| <b>Project Title:</b>   | Blythe Solar Power Project - Compliance                      |
| <b>Document Title:</b>  | Comments of CRIT on the Blythe Solar Power Project Amendment |

### **Re: Comments of the Colorado River Indian Tribes on the Blythe Solar Power Project Amendment (09-AFC-6C)**

**Multiple Use Classes within the Cadiz Valley and Chocolate Mountains Ecoregion** FIGURE 3.7-8

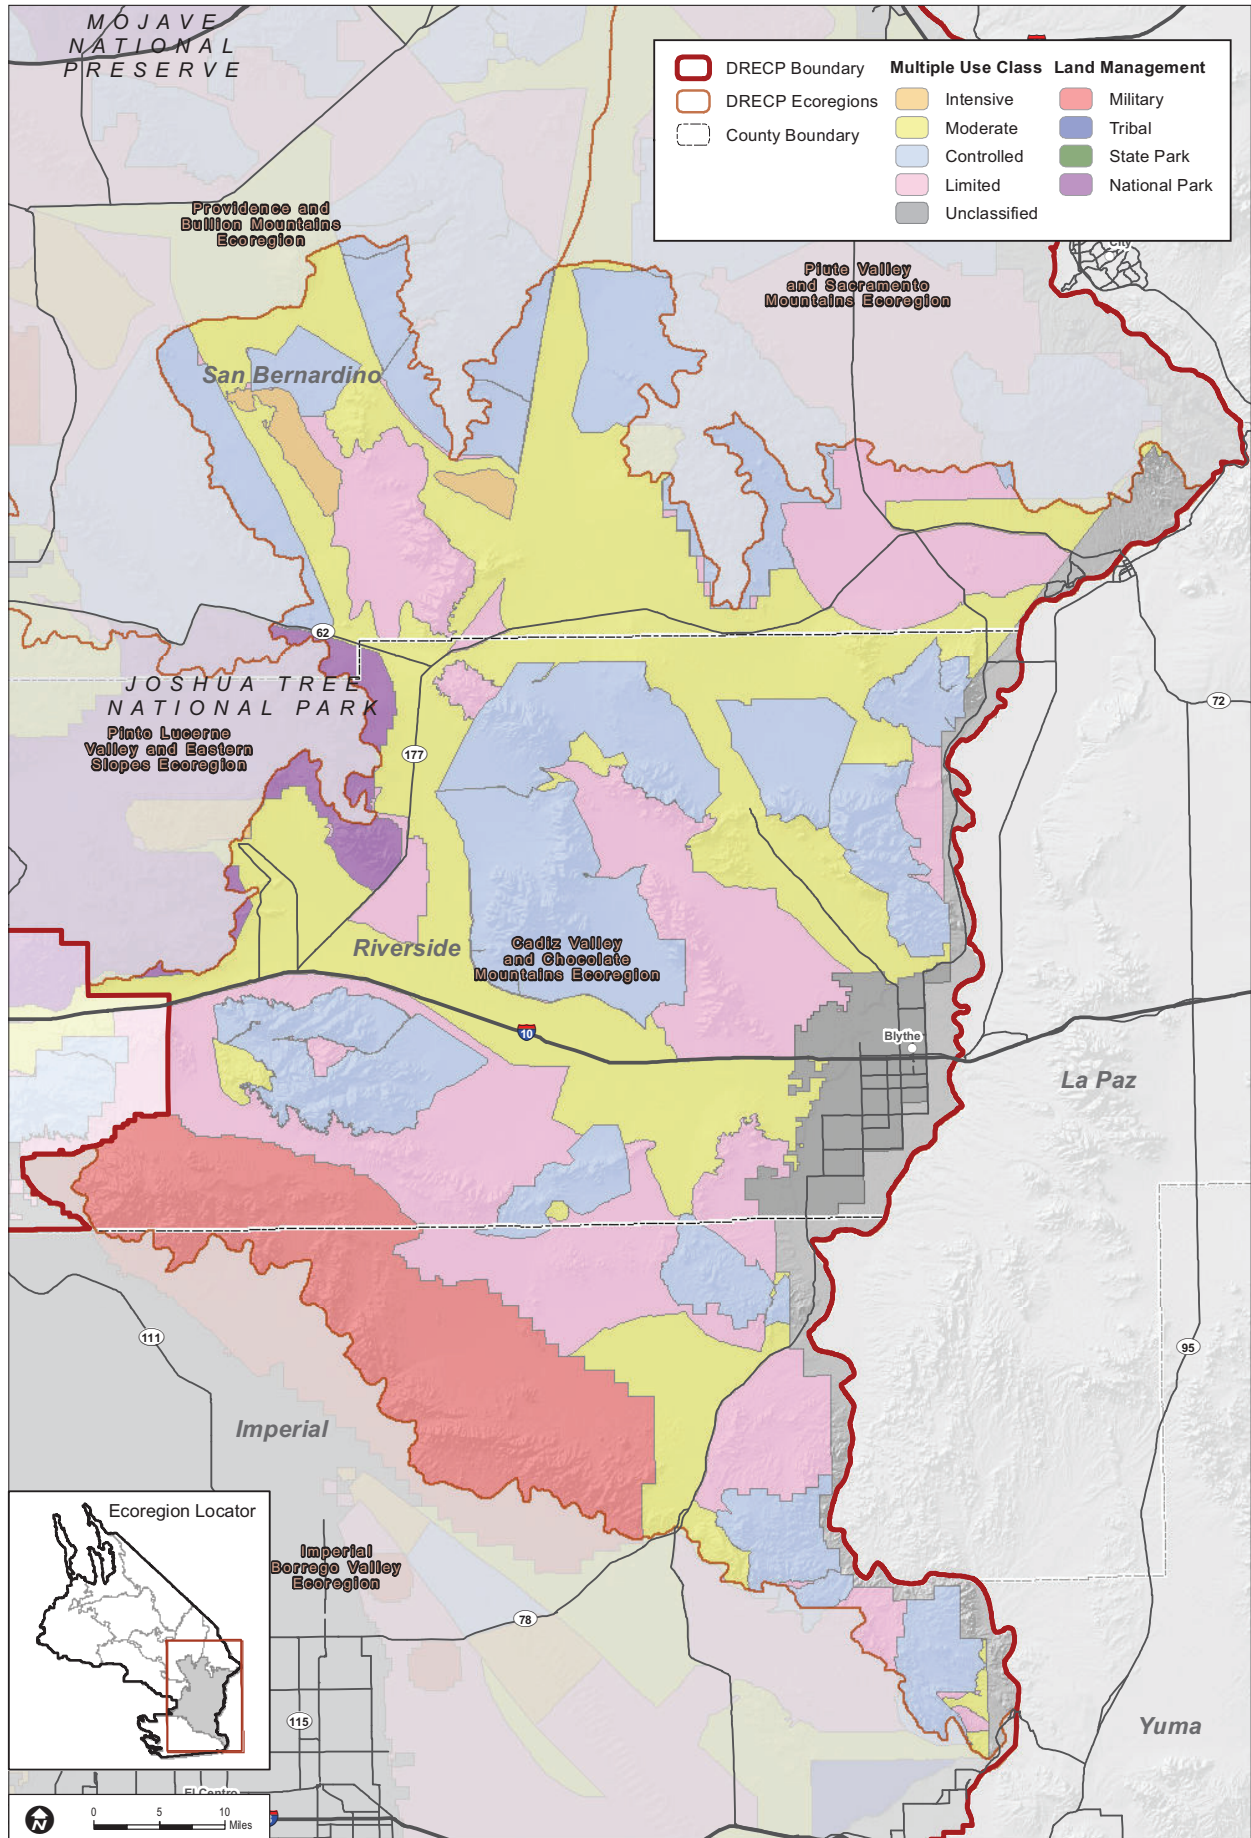
The SA claims that the Project is located entirely on lands classified as “Class M” under the California Desert Conservation Act (CDCA) Plan. SA 4.5-6. This information is incorrect. According to the Final EIS for the prior project, as well as maps of the CDCA Plan, the proposed Project is located entirely on “Class L” Lands. Blythe Solar Power Project PA/FEIS, at 1-6; Desert Renewable Energy Conservation Plan, Description and Comparative Evaluation of Draft DRECP Alternatives, Figure 3.7-8, Multiple Use Classes within the Cadiz Valley and Chocolate Mountains Ecoregion (attached as Exhibit 2).
